Project	IEEE 802.16 Broadband Wireless Access Working Group < http://ieee802.org/16 >	
Title	Suggested modifications to “IEEE Std 802.16e™-2005 and IEEE Std 802.16™-2004/Cor 1-2005” to support AK Caching Solution	
Date Submitted	2006-07-07	
Source(s)	NWG Simon Mizikovsky, Robert Rance (Lucent Technologies) Voice: +1 973-386-6348 Philip Barber (Huawei, Inc.) Fax: 973-386-4555 Jicheol Lee, Guenhwi Lim (Samsung) mailto:smizikovsky@lucent.com , Yerang Hur (Posdata) rance@lucent.com Kiseon Ryu (LG) Voice: +1 972-365-6314, pbarber@huawei.com Avishay Shraga (Intel)	
Re:	Call for contribution and comments. Addresses Comment #444 which calls this document by its former name of "060501_Suggested mods to 802.16e to support AK Caching Solution_Lucent_Mizikovsky_Simon_Huawei_Barber_Phillip.doc".

Modifications for AK Caching Solution

Change 1. Modify generation of the CMAC_KEY_*

Figure 130o—HMAC/CMAC/KEK derivation from AK

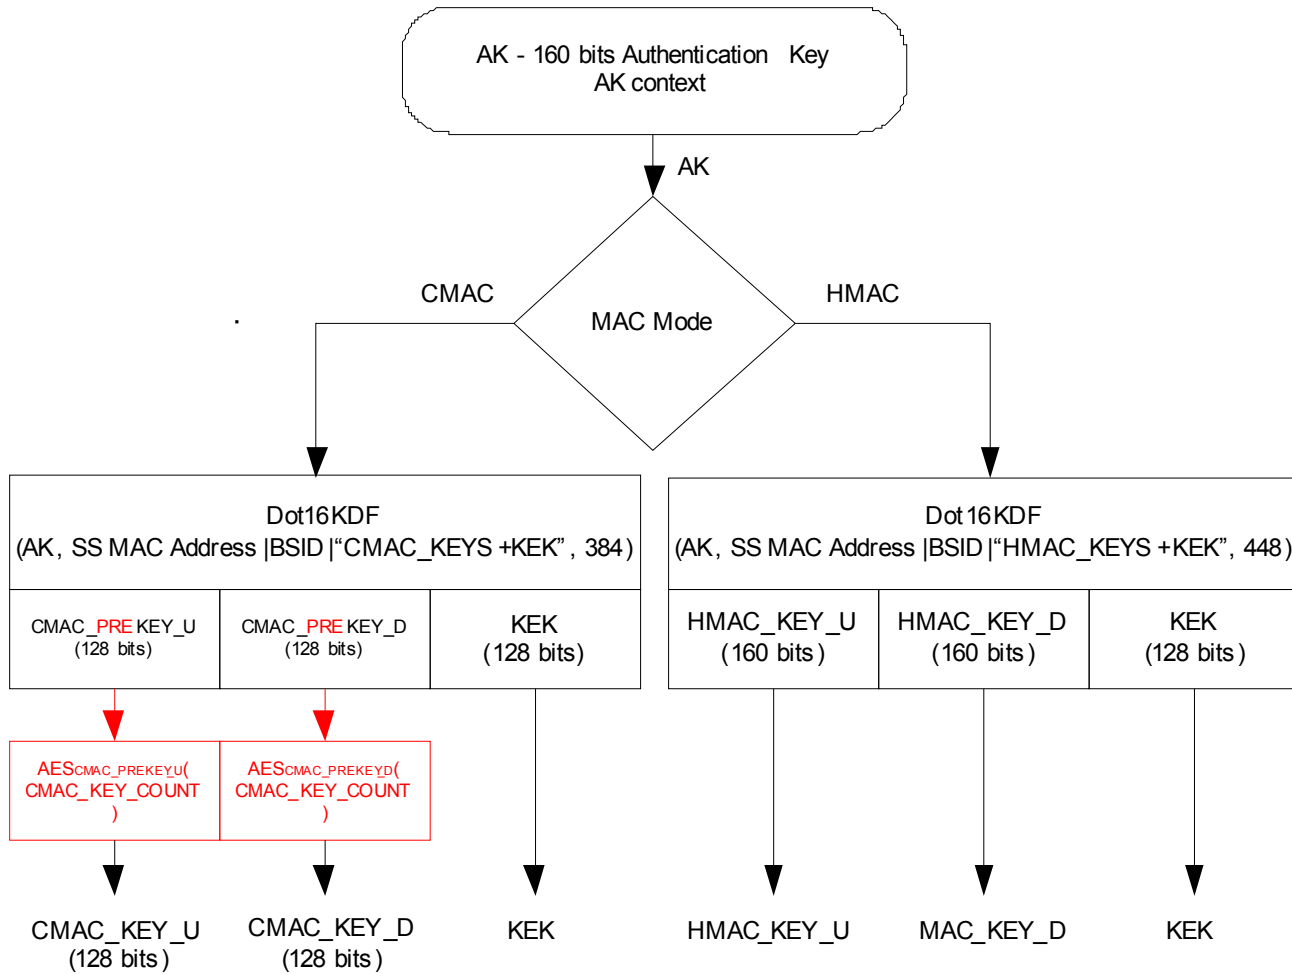
10. Add Change 6 (suggested by Phillip Barber): Modify Figure 130o to show new CMAC Key derivation.
11. Add to Change 5 (suggested by Bob Rance): or perform a secure Location Update.

Change 6: Modify CMAC Key derivation figure.

[Please insert the red text and graphics as follows in Figure 130o, page 283 of 802.16e-2005]
